Intel[®] L440GX+ Server Board
Technical Specification Update

Order Number: 245145-027

June 2001

Figure 1-1. L440GX+ Server Board Layout

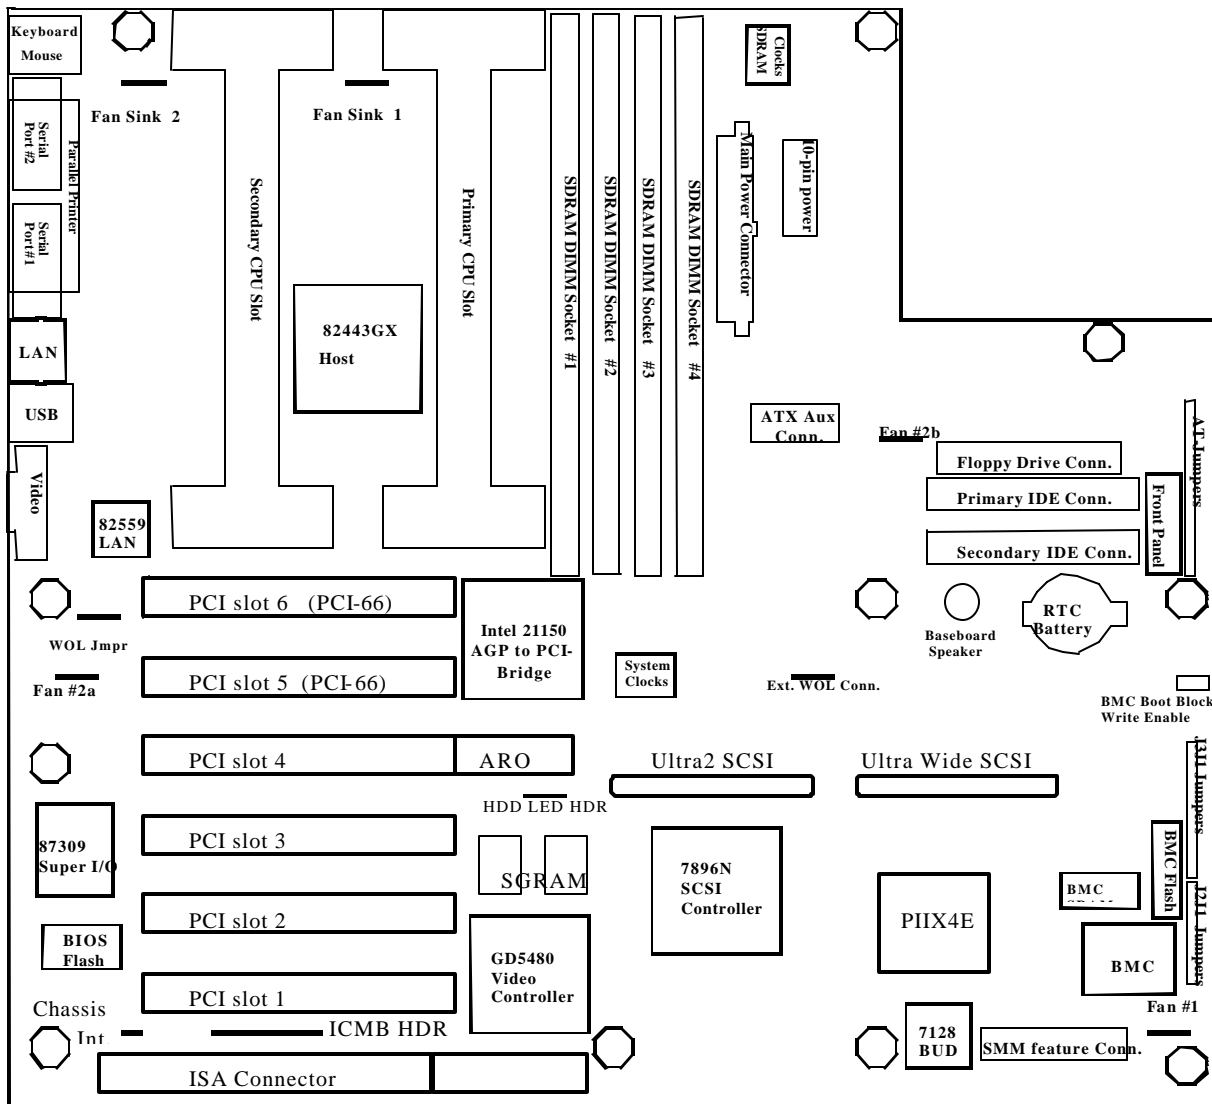
- Update to the L440GX+ component placement diagram, as shown in the rev 3.0 Technical Product Specification. The new diagram shows the addition of the 10-pin power connector found on L440GX+ server boards having a product code of BOXL440GX-H and later. The 10-pin power connector is used when the L440GX+ server board is integrated into an Intel SC5000 server chassis with redundant power supplies.
